TECHNICAL BULLETIN

Ref Document No.	TB15002	Issue No.	1
Subject	Accelerator pedal position sensor - Mechanical upgrade		
Release Date	12/03/15

Figure 1.0.

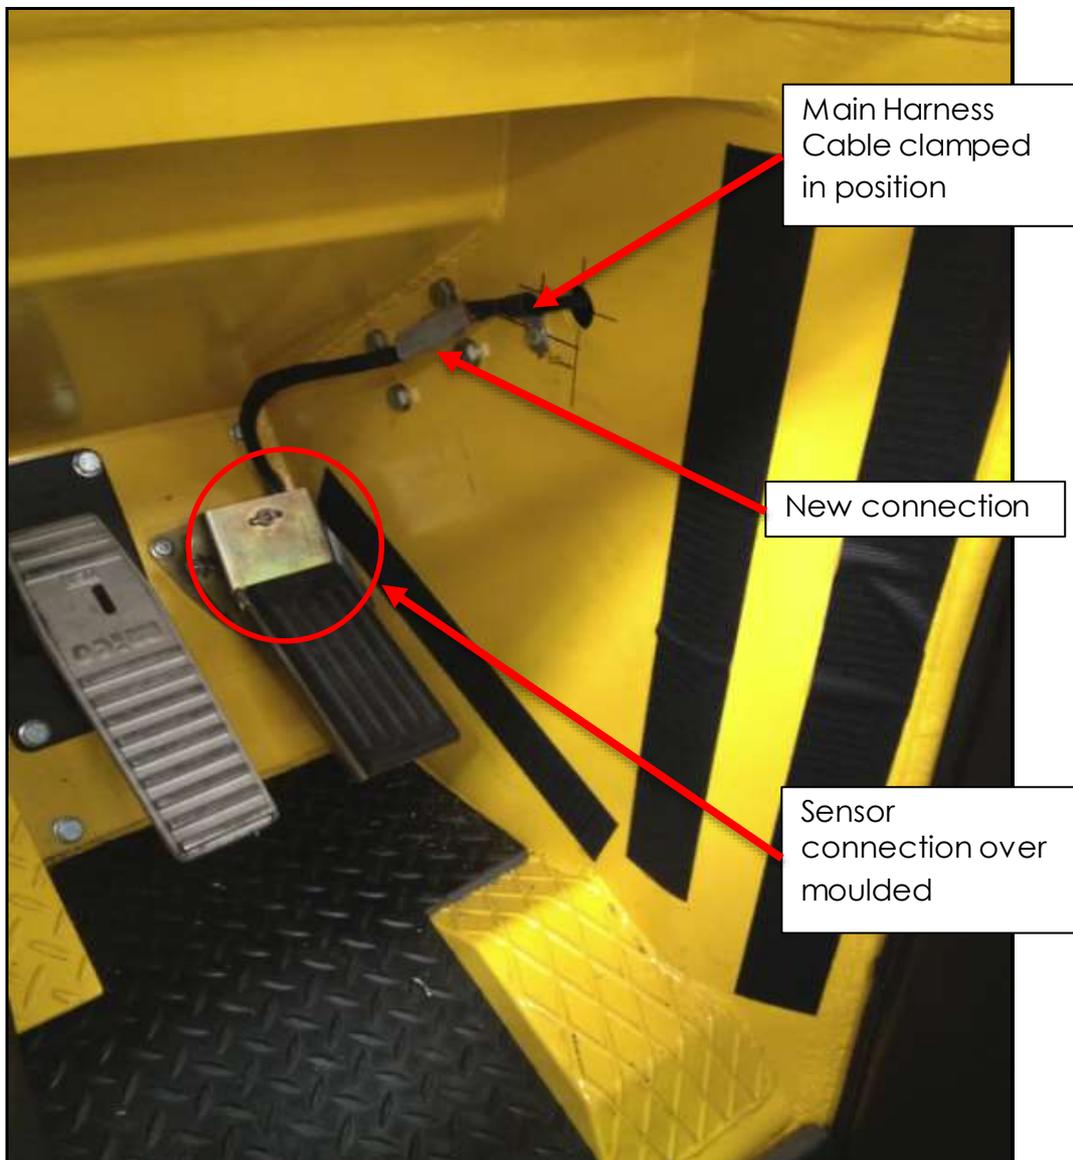
PPK identified that the current location of the sensor's electrical connection would be frequently subjected to water and other contaminants.

To achieve the outcomes from the FMEA, PPK's new accelerator pedal position sensor will be supplied with a 600mm cable extension. The sensor's existing electrical connection will be over-moulded to fully encapsulate the connection.

The sensor's 600mm cable extension, will be connected to the main harness at a higher point in the cabin foot well. The new connection will also be located behind sound suppression padding when installed.

The new connection can be seen in figure 1.0 below:
